# COMMISSION OF ARCHITECTURAL REVIEW

## APPLICATION FOR CERTIFICATE OF APPROPRIATENESS

Address 2209 E. Grace Street

RICHMOND HILL  
RESTORATION

C1 GATE ELEVATION

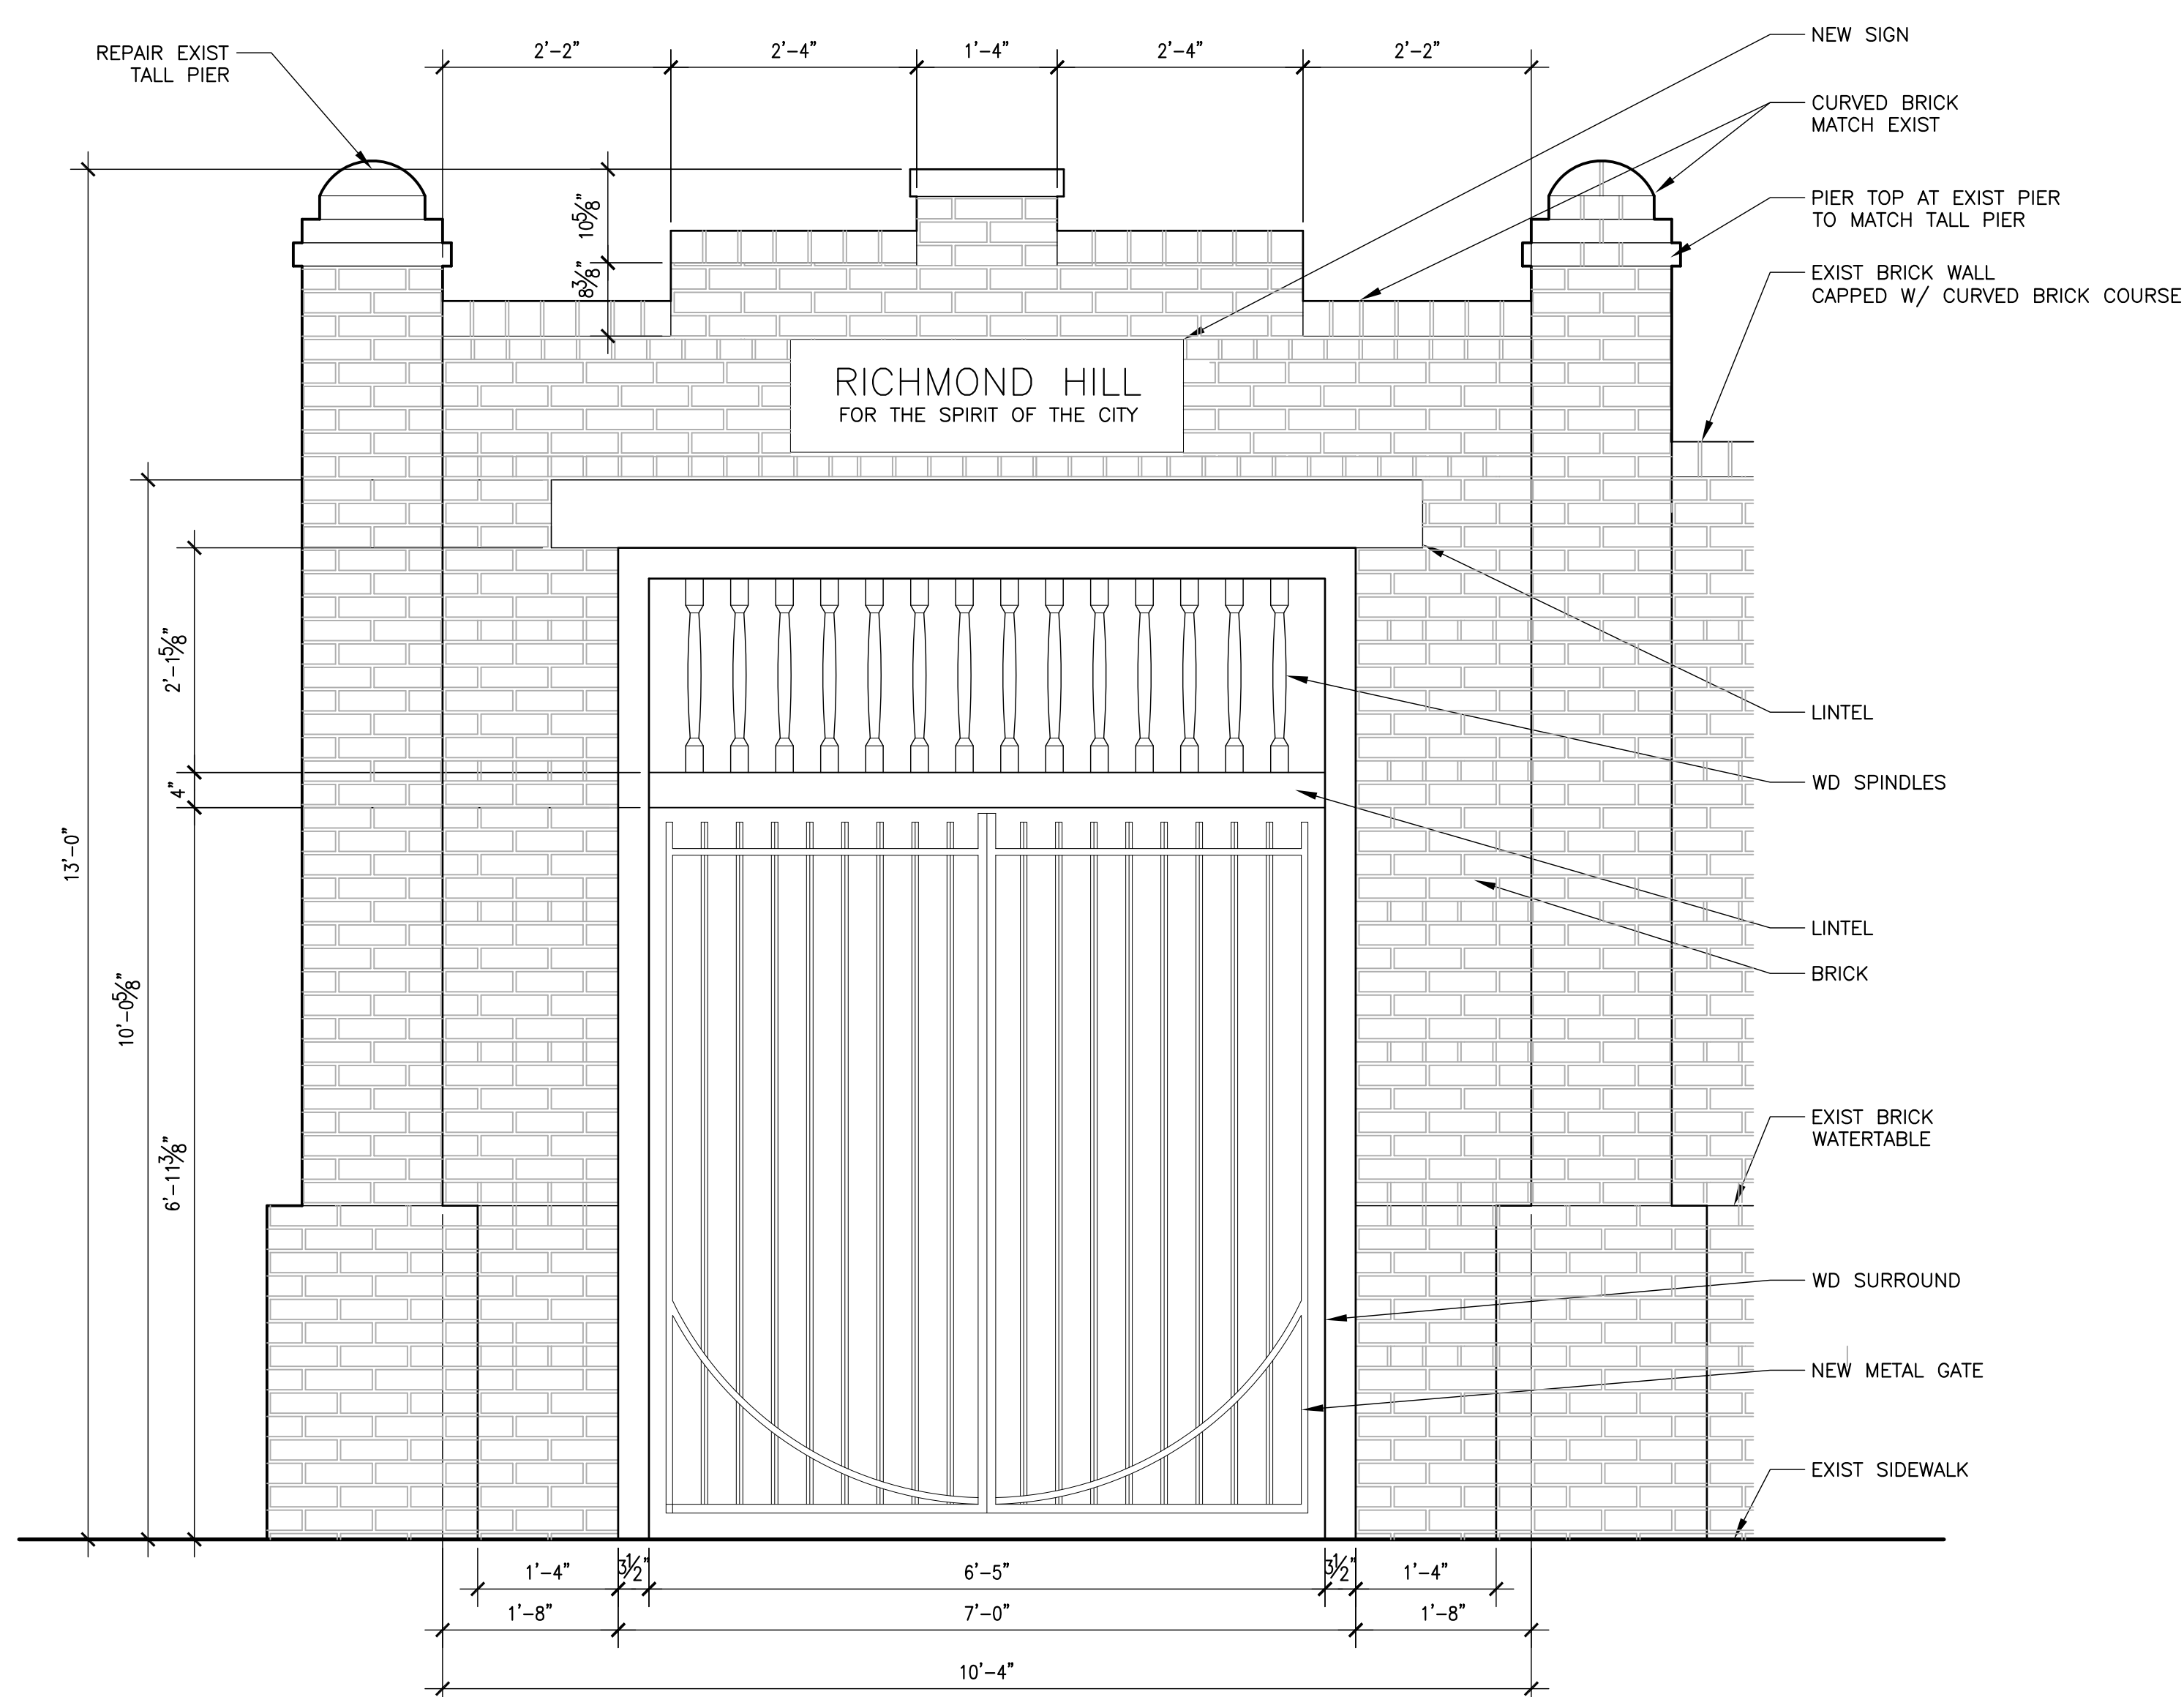
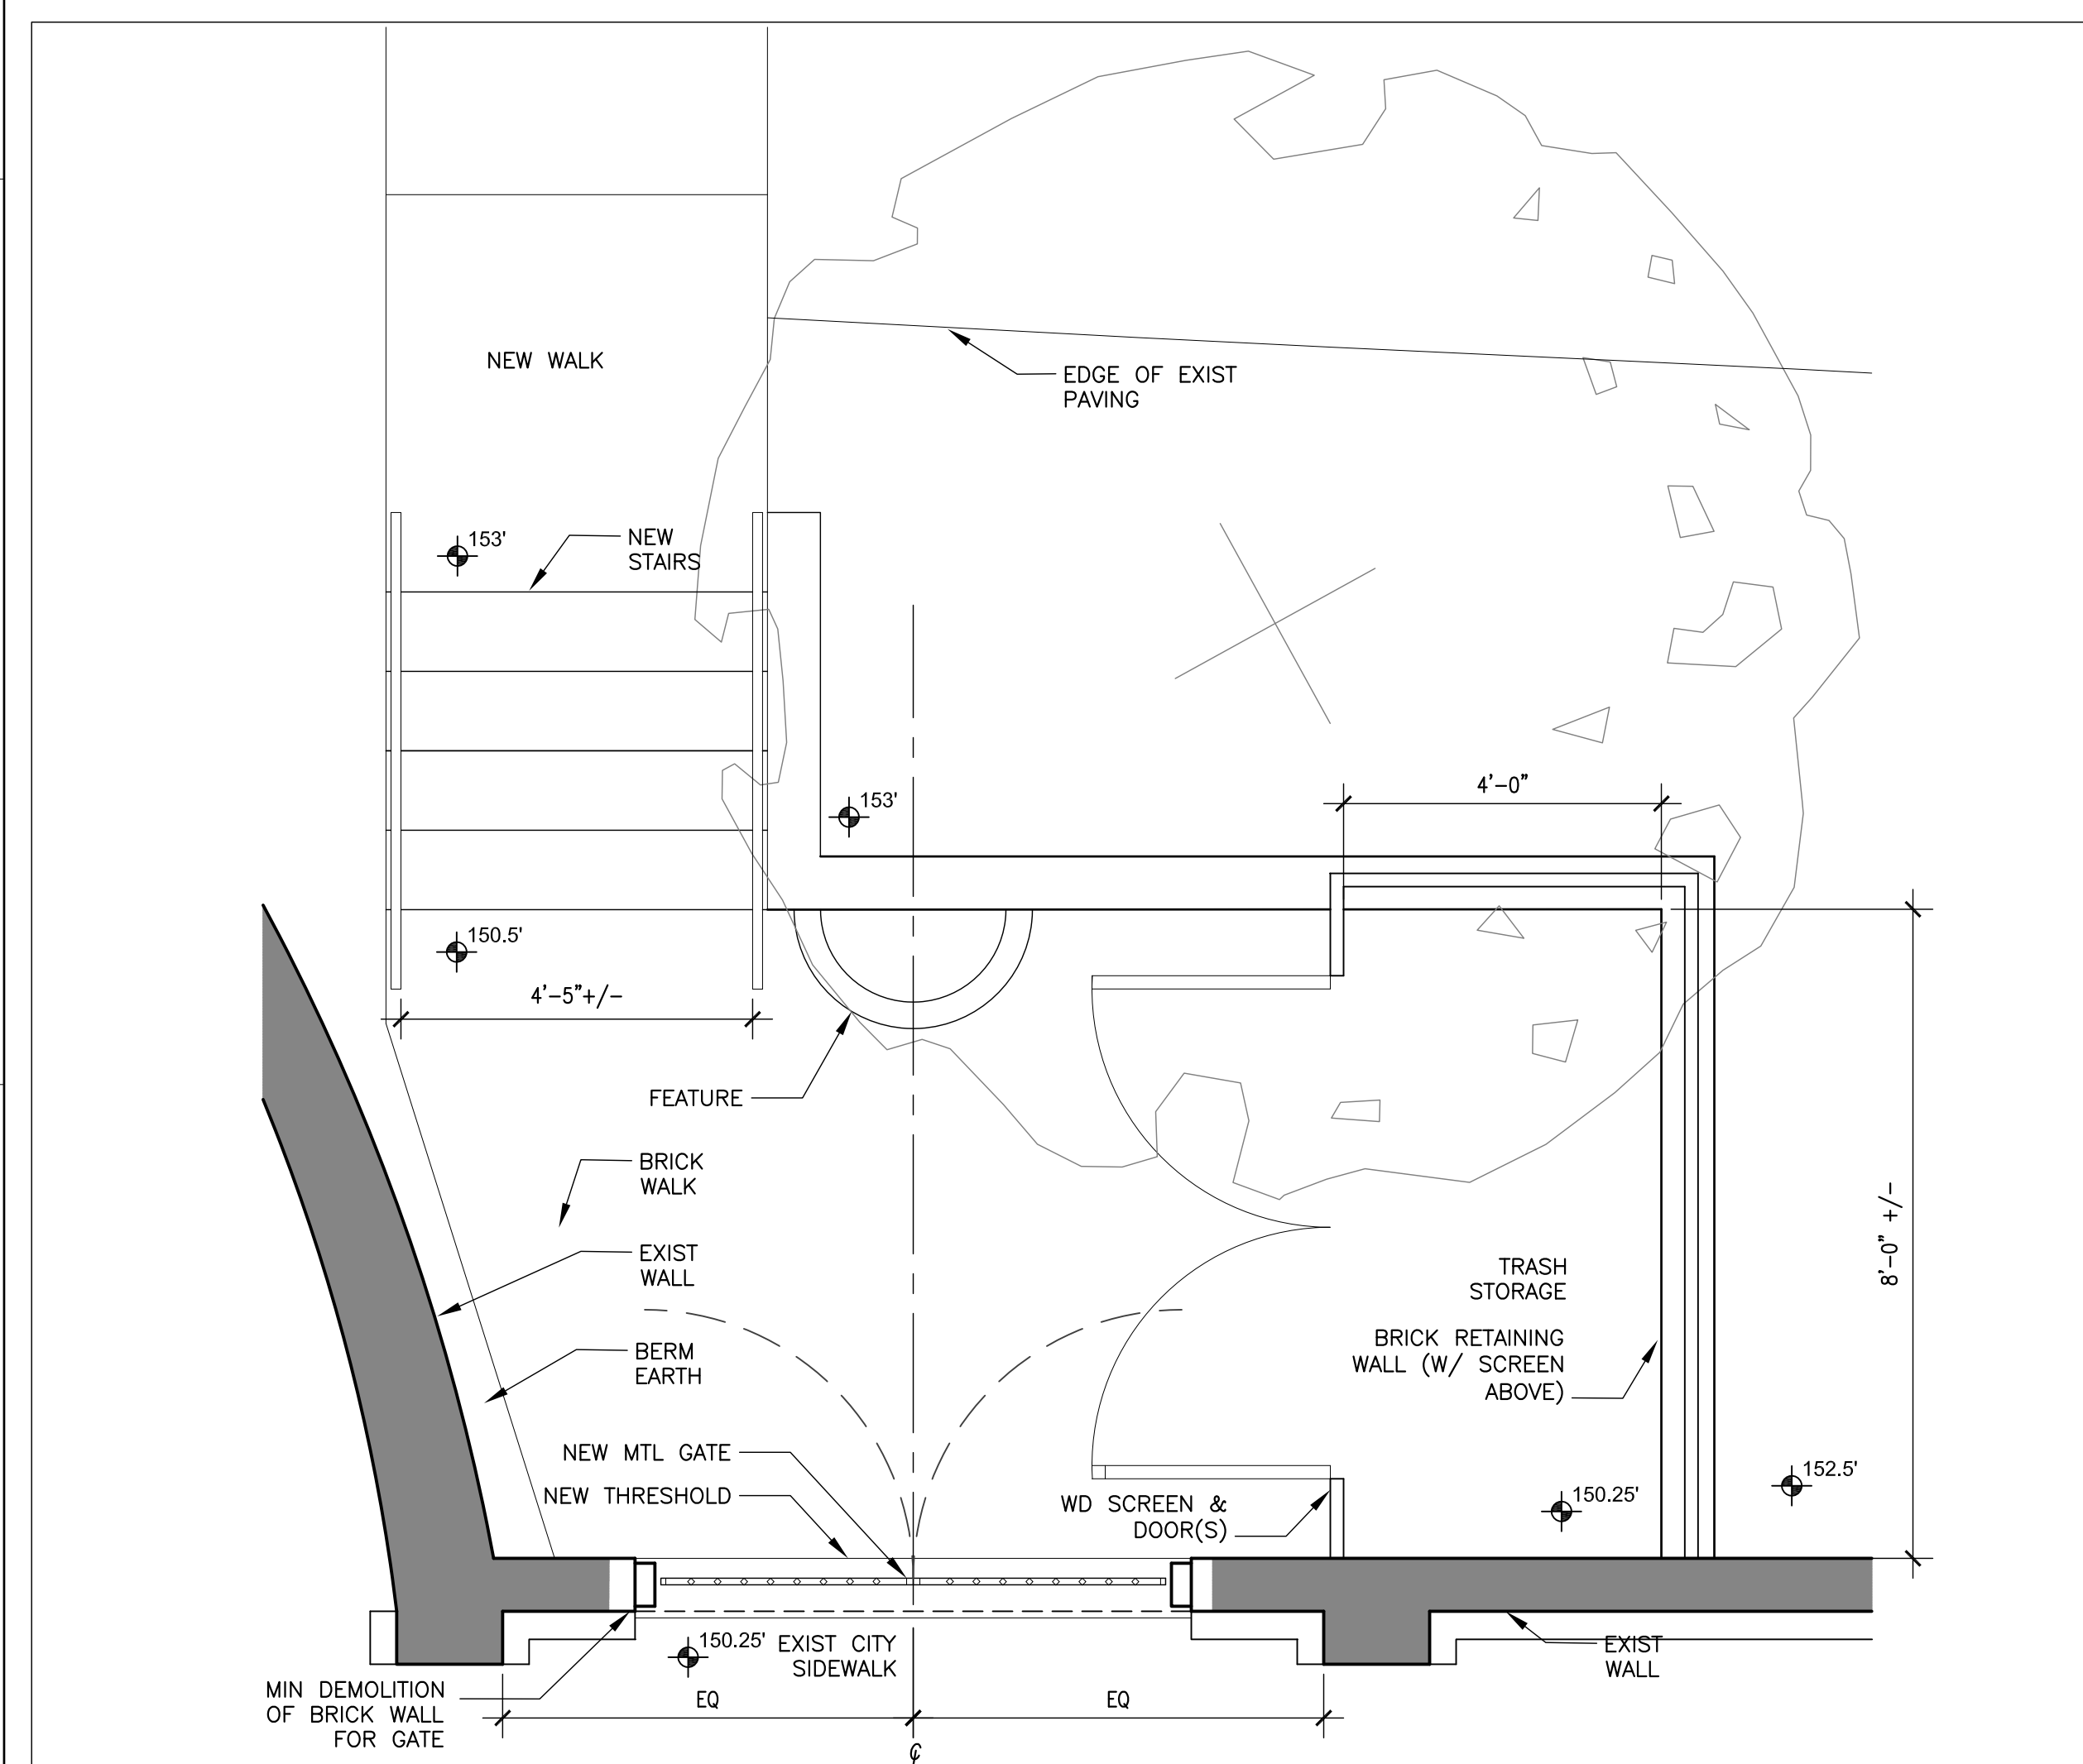
Thank you for dropping off the additional information this afternoon. Staff has started a preliminary review of this application and we are wondering why the new gate is necessary when there is a door nearby. The plans indicate the door is going to be secured. Is there the possibility of using this door instead of a new gate?

Carey- There is a small arched access former service door in the curved area of the wall on the raised area in front of the chapel. It is not an obvious, welcoming, or readily accessible door for the public to use. The idea here is to create a welcoming entry for pedestrians to access the main entry to the building without coming in the vehicle gate, located at the back of the parking area and which is the only public access to the building, except when the chapel door is opened during services. It would also be available off-hours when the vehicle gate is closed, by use of an intercom and electrically controlled lock.
